# 1961 Corvette: Service Bulletin: Corvette Grille Vibration

**Subject:** Corvette Grille Vibration

**Model Year:** 1961 Corvette

**Date:** February 2, 1961

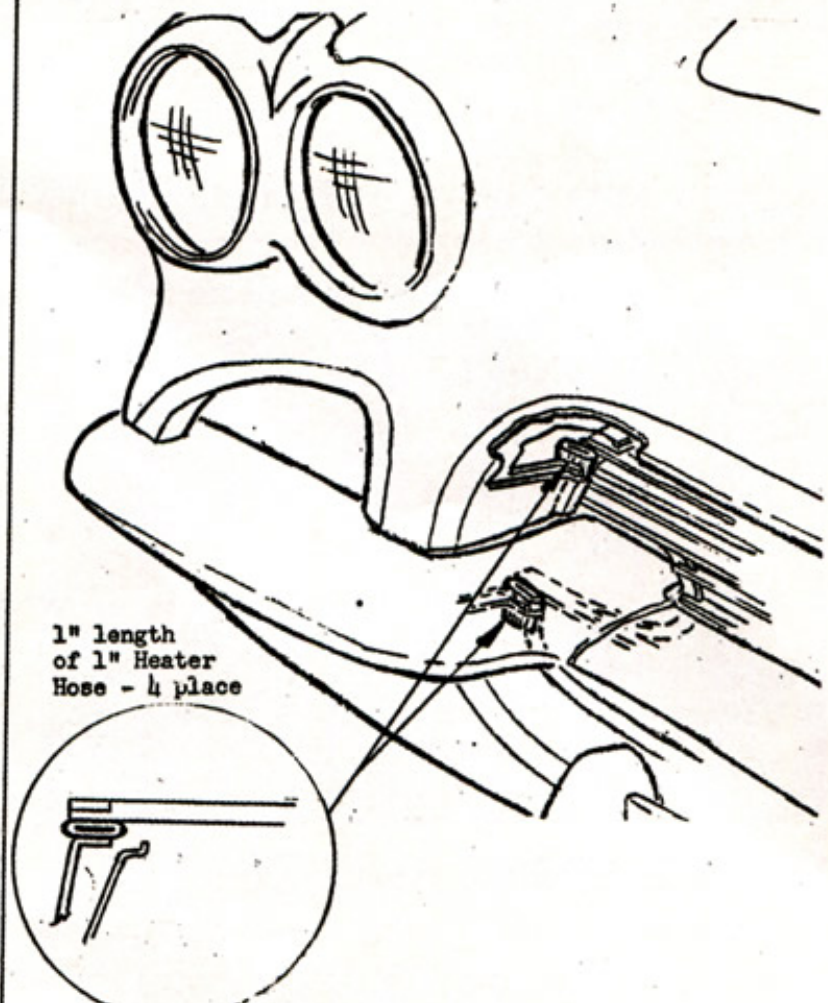
A shrill whistling noise on early production Corvette Models at speeds of 40-60 MPH may be caused by grille vibration. The condition can be minimized by wedging four (4) one inch long pieces of one inch I.D. heater hose between the grille and front end sheet metal as illustrated.
